Addendum #1

Awarding Authority: MA Department of Fish & Game, Office of Fishing and Boating Access

**Project: PA-416 Boating Access Facility Improvements,
Jericho Road Boat Ramp, Scituate Harbor, Scituate, MA**

Date: February 5, 2025

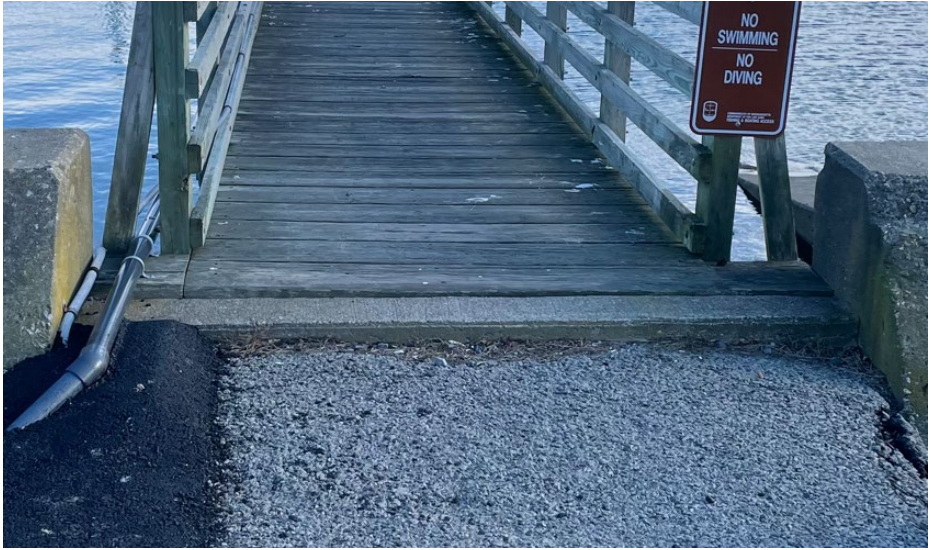
15. Can you please specify the material for the sealant to be used on the detail 'Typical Elastomeric Joint Filler', and associated backer rod material.

Response: Elastomeric Grout for the seawall joints is specified on sheet G-002.
